STATE OF OHIO
DEPARTMENT OF TRANSPORTATION
HUR-CR 11-2.96
BASELINE ROAD/BROADWAY ST.
VILLAGE OF PLYMOUTH
HURON COUNTY
RICHLAND COUNTY

REPLACEMENT OF A DETERIORATED WOOD BEAM BRIDGE OVER ASHLAND RAILWAY IN VILLAGE OF PLYMOUTH ON EXISTING HORIZONTAL ALIGNMENT AND MODIFIED VERTICAL ALIGNMENT WITH APPROACH ROADWAY WORK.

ADDENDUM 1

MSE WALL 2 - PLAN AND ELEVATION
HU-CR-11-2.96
BASELINE RD./BROADWAY ST. OVER ASHLAND RAILWAY

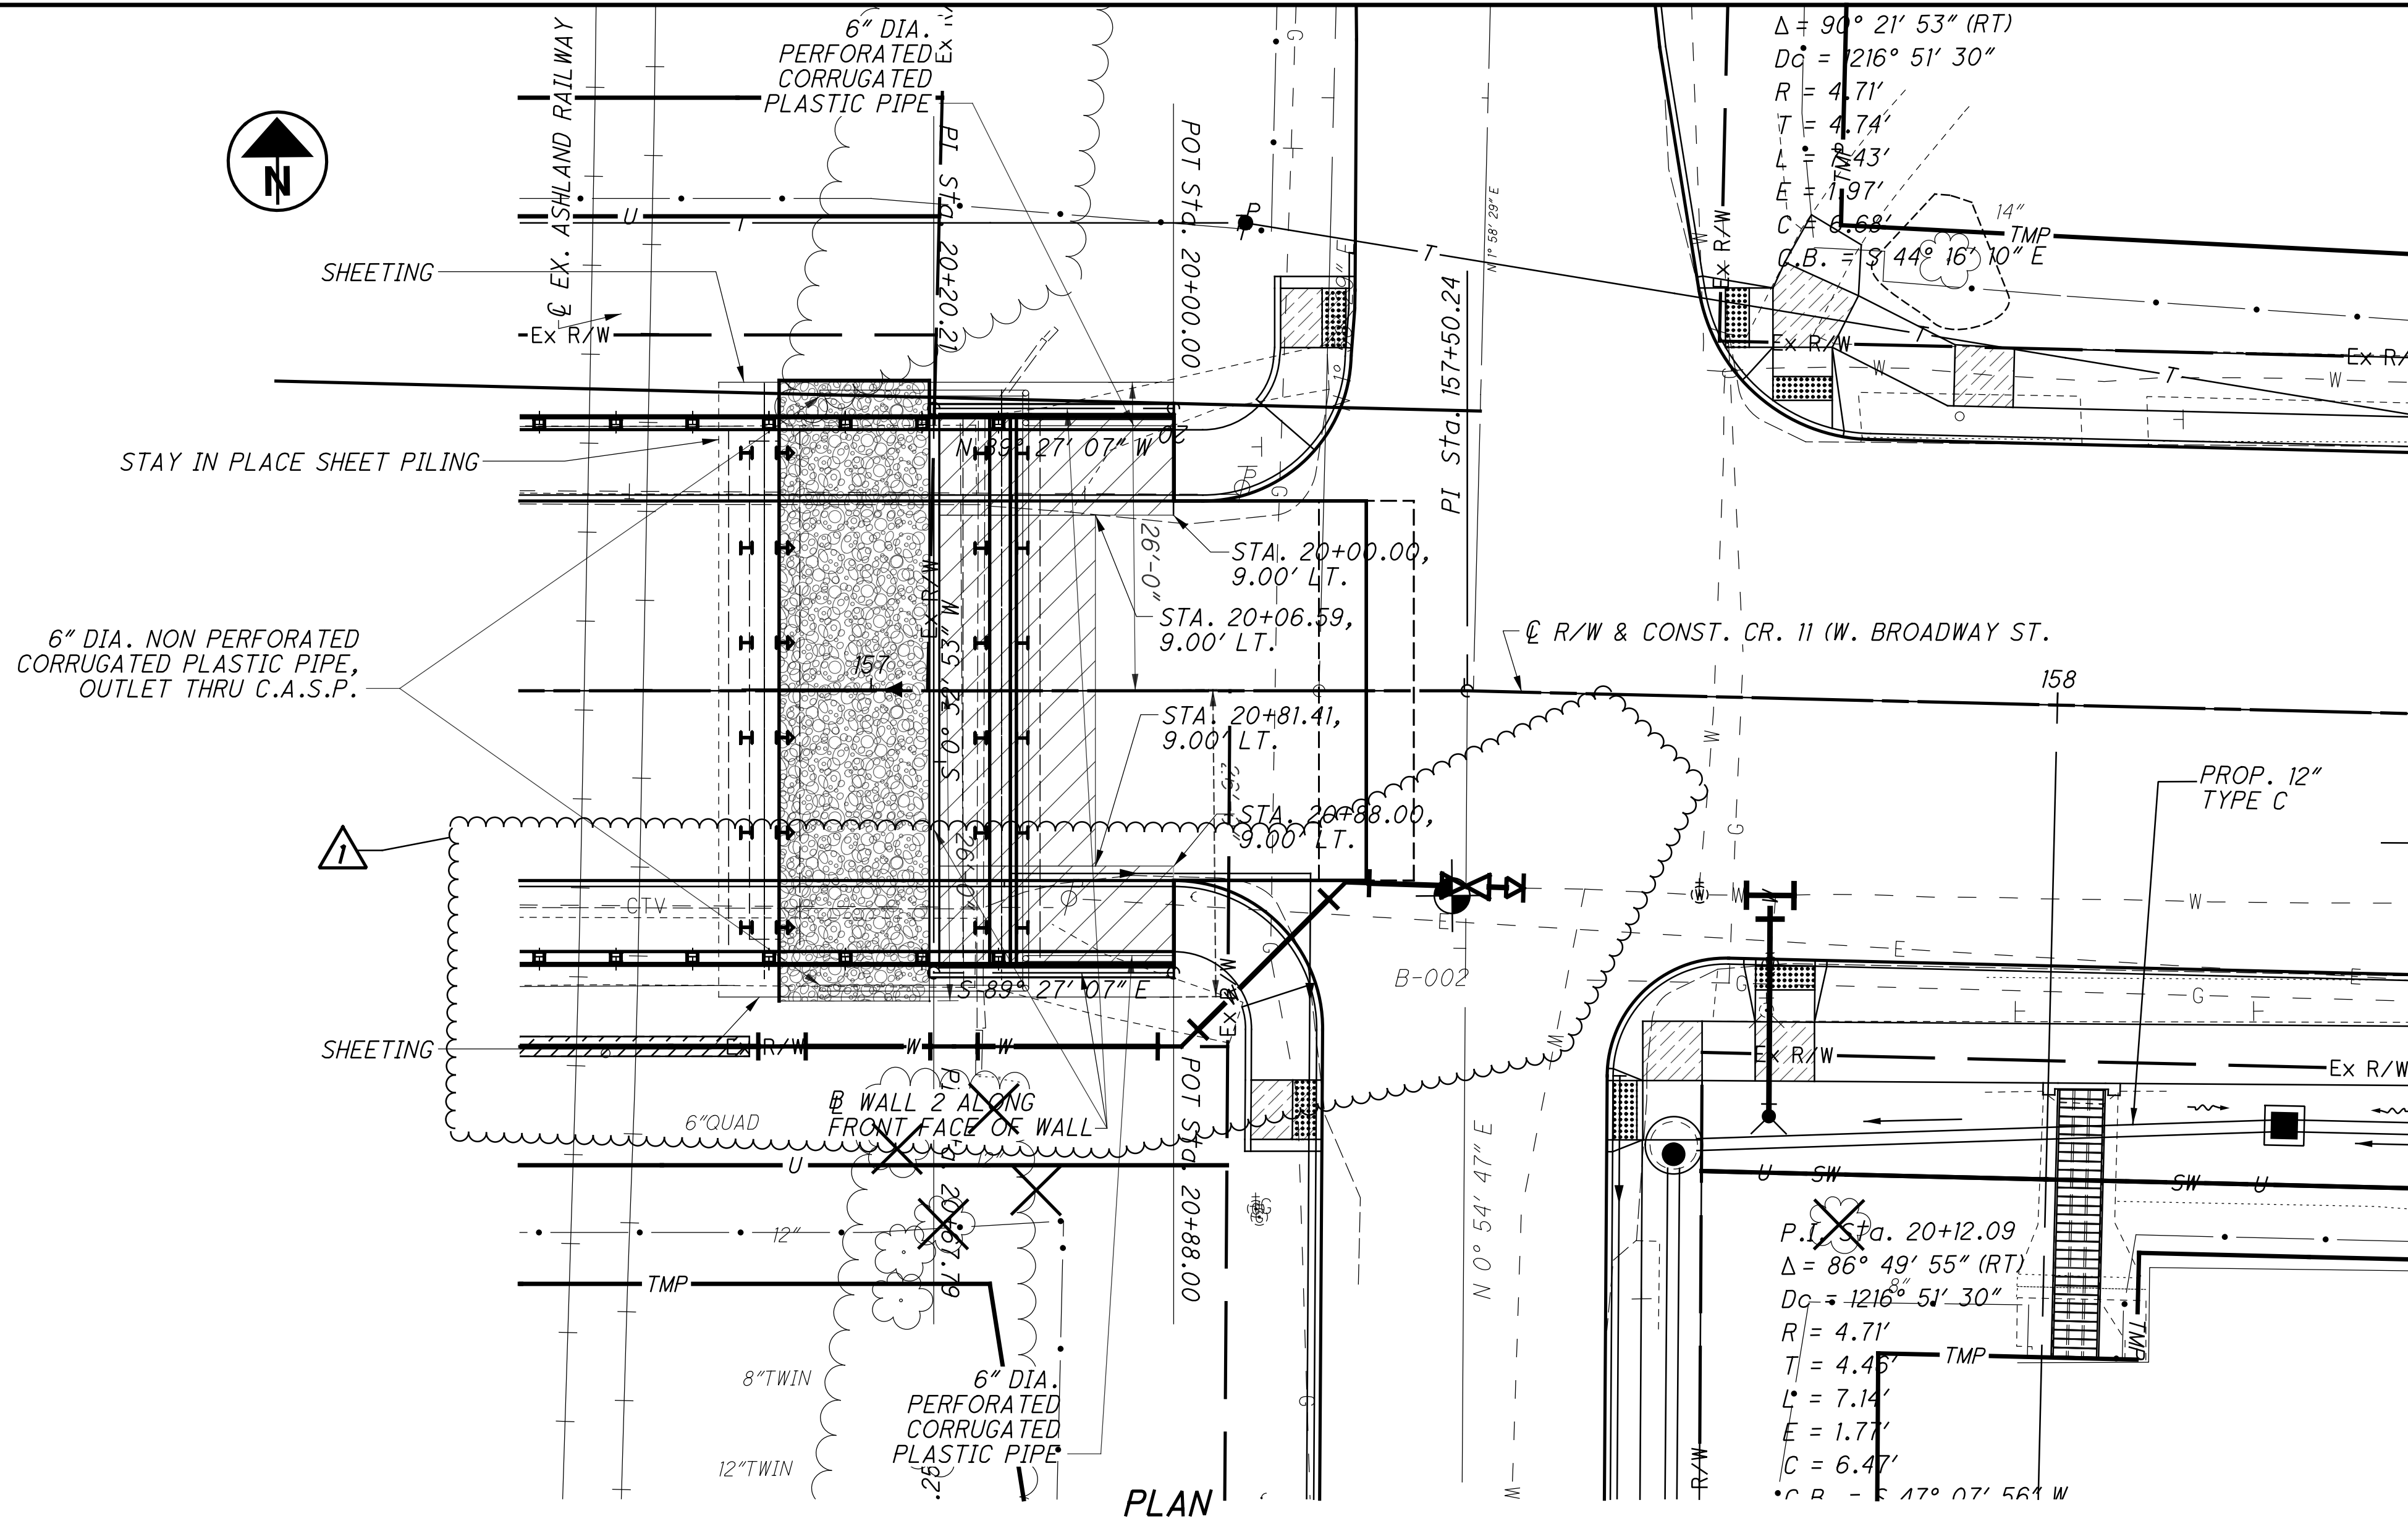
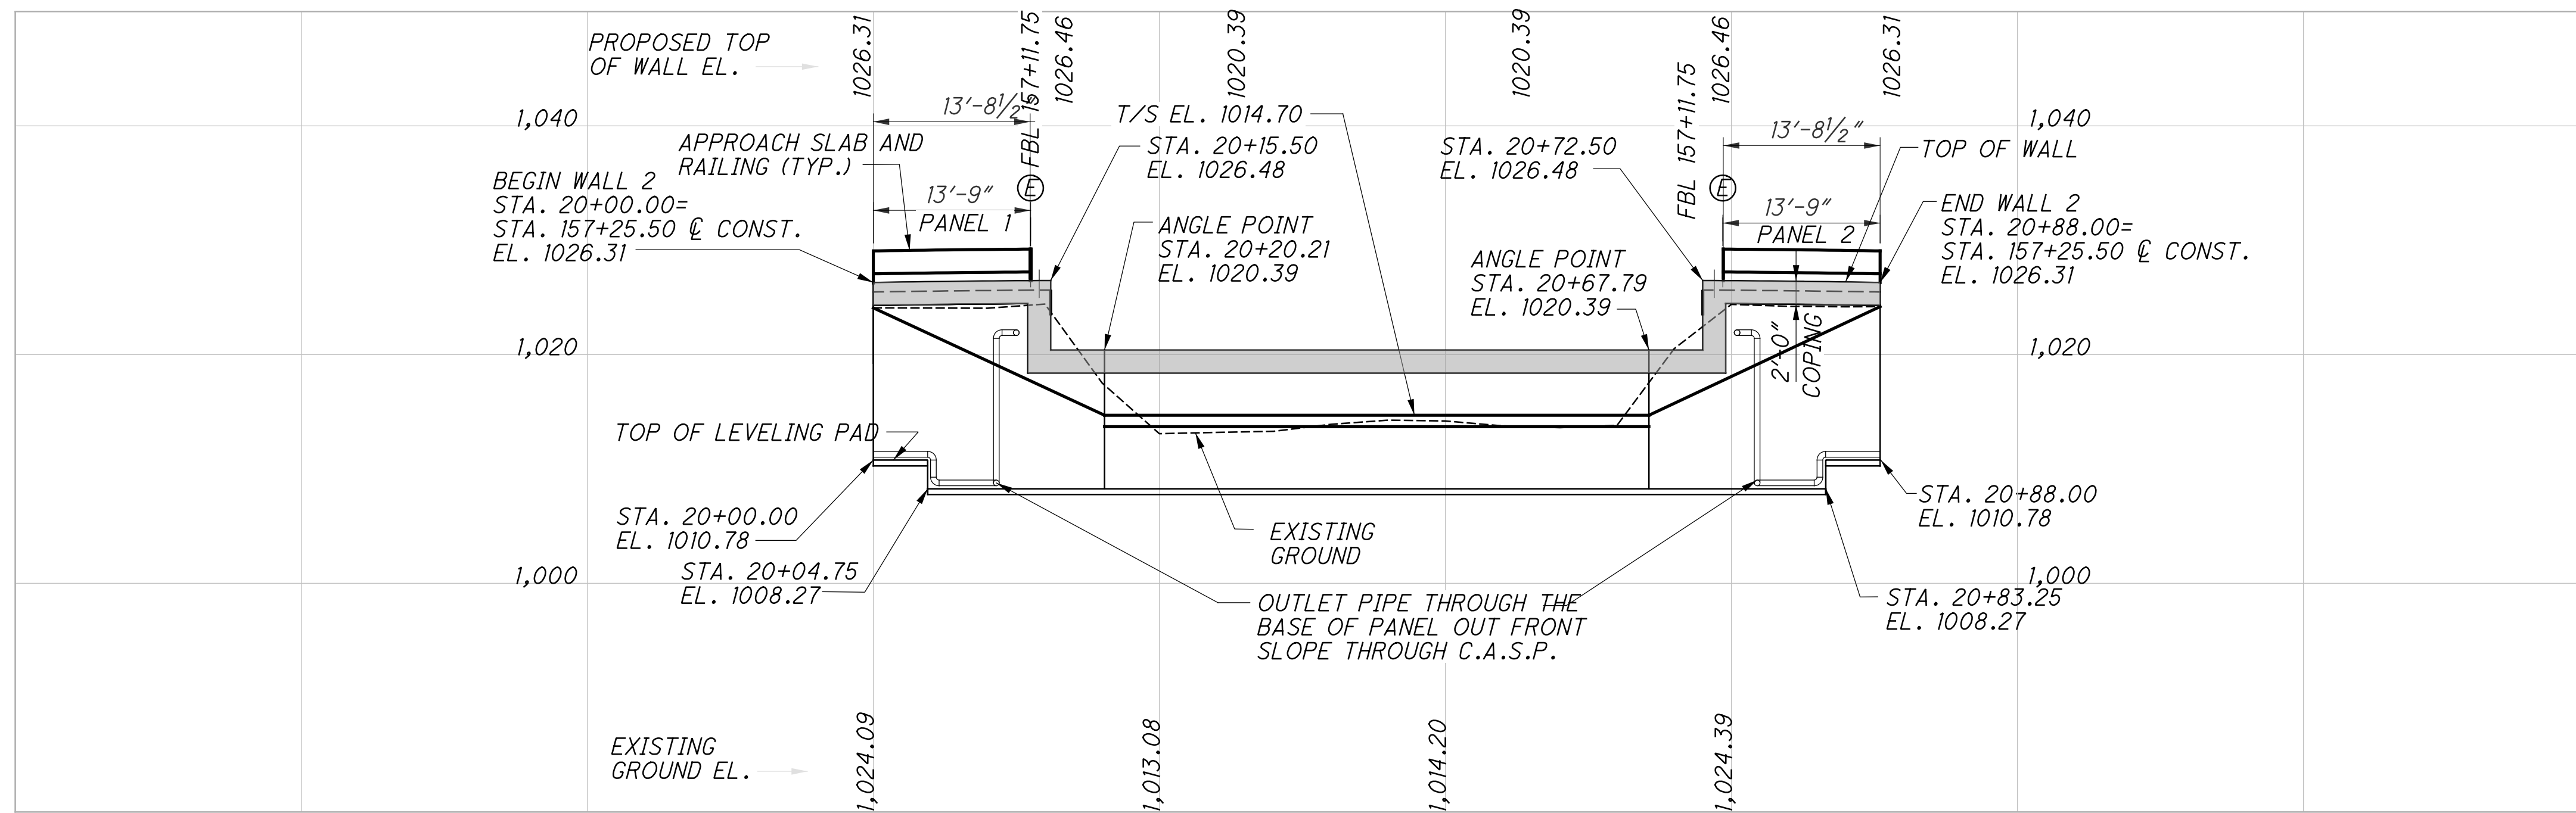
| ADDENDUM 1 | |
|------------|--------------------------------|
| 4/13/26 | REVISED DRAINAGE AND WATERLINE |
